Accessibility Survey

City of Downey Charloma Drive - Birchdale Avenue to Cul-De-Sac

City of Downey Charloma Drive - Brookshire Avenue to Stamps Avenue

Date of Inspection
7/10/2017

Bush West of Brookshire Avenue @ 33.953683940663, -118.119374066591

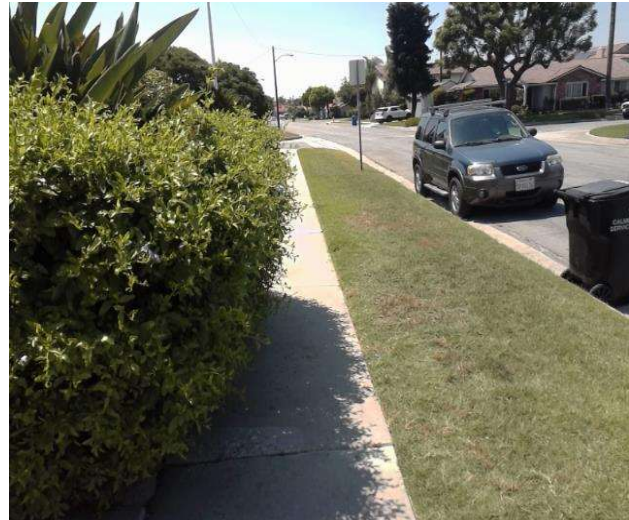
Sidewalks , Hazards & Gratings : Sidewalk Width at Obstruction

Sidewalk width at the obstruction is not compliant.

On-Site Finding 23.00 inches

Sidewalk width at the obstruction shall have the recommended value.

Recommendation At least 48.00 inches

Tree West of Manzanar Avenue @ 33.954211231743, -118.120308816433

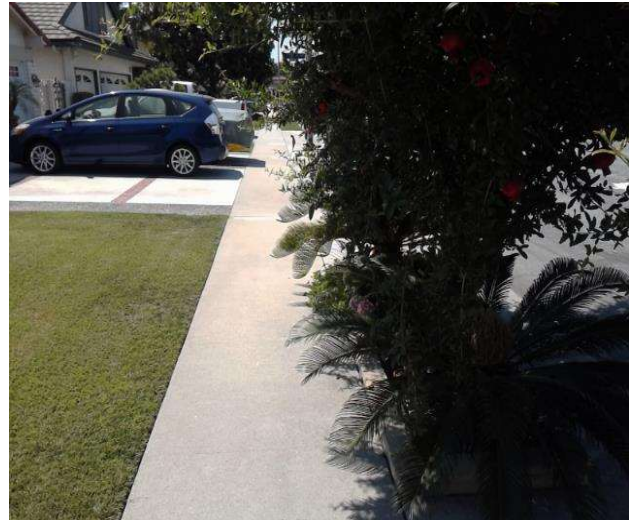
Sidewalks , Hazards & Gratings : Sidewalk Width at Obstruction

Sidewalk width at the obstruction is not compliant.

On-Site Finding 29.00 inches

Sidewalk width at the obstruction shall have the recommended value.

Recommendation At least 48.00 inches
